UNITED STATES
DEPARTMENT OF THE INTERIOR
BUREAU OF LAND MANAGEMENTFORM APPROVED
OMB NO. 1004-0137
Expires: January 31, 2018**SUNDRY NOTICES AND REPORTS ON WELLS**
*Do not use this form for proposals to drill or to re-enter an abandoned well. Use form 3160-3 (APD) for such proposals.***SUBMIT IN TRIPLICATE - Other instructions on page 2**

** BLM REVISED ** BLM REVISED ** BLM REVISED ** BLM REVISED ** BLM REVISED **

Proposed Wellbore

PALLADIUM 7 FEDERAL #010

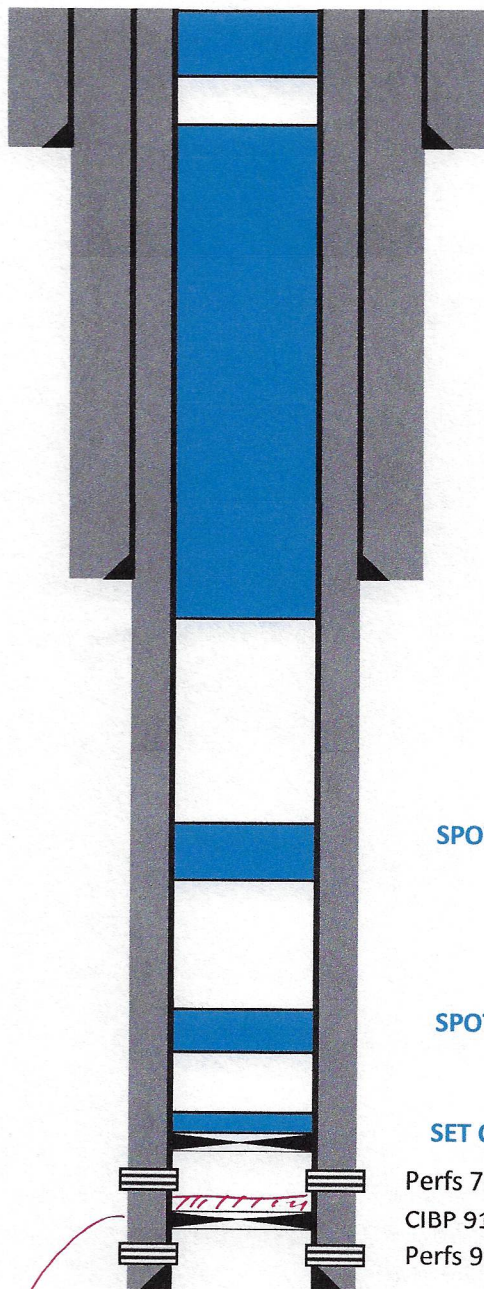
SPOT 90 SX CLASS C CMT 4320-900.

SPOT 455 SX CLASS C CMT 4320-900.

35 SX

4329' - 4004'

WOC & TALT

Leak test
CFBP

10# MLF between plugs. Utilize above ground steel tanks.
TAG CIBP @ 9120'. Dump Bail 5 SX class H. TAG
 SET CIBP AT 7825. DUMP BAIL 5 SX CLASS H CMT. TAG *Leak test CIBP*
 SPOT 25 SX CLASS C CMT 6543-6356.
 SPOT 25 SX CLASS C CMT 5239-5052.
 SPOT ~~455 SX CLASS C CMT 4320-900~~ *Spot 35 SX (4329' - 4004') WOC & TAG*
 SPOT ~~90 SX CLASS C CMT 4320-900~~
Perf & Spz 110 SX @ 1055' (1055' - surface) Verify @ surface
